Subject: Bicycle Parking Requirements

Now, for one example: a 2016 site plan for the Maple Village shopping center's parking lot improvements (project SP15-052 in etrakit - <https://etrakit.a2gov.org/etrakit/Search/project.aspx?activityNo=SP15-052>) promised to include the (required) 88 bicycle parking spaces using 4 "Belson Model H36-21-G-SF" bike racks dispersed through the development, e.g.:

This Belson rack is what's more commonly known as a "wave rack" design. Here is a dimensional drawing from the manufacturer (<https://www.belson.com/Dimensions/H36-21-G-SF-Dimensions.pdf>):

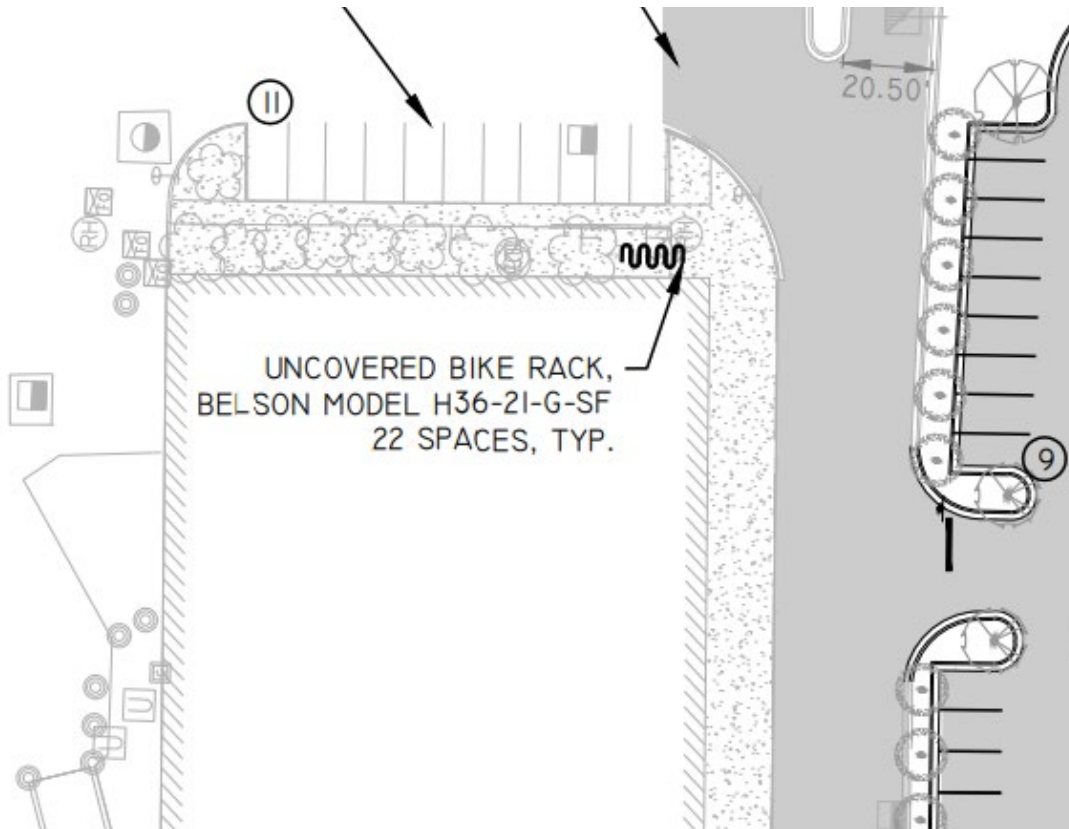
This rack claims to have a capacity for 21 bikes. Some very simple math would show, then, that it does not meet the city's existing standards, which again state: "One Bicycle Parking Space shall consist of a space not less than **two feet wide** by six feet long". In this rack, bicycle parking spaces are - interpreting measurements generously - about 1 foot wide, not 2.

Now, to the second point: it could be argued that this type of rack might still be allowed under the existing UDC if we simply cut its stated capacity in half, i.e. this rack could be used to provide 11 spaces, not 21, because then each bike would get ~2ft of space. This is where I believe our code should be improved and strengthened, because if the city seeks to promote cycling for all ages and abilities, as a serious mode of transportation, then this rack design should *never* be permitted.
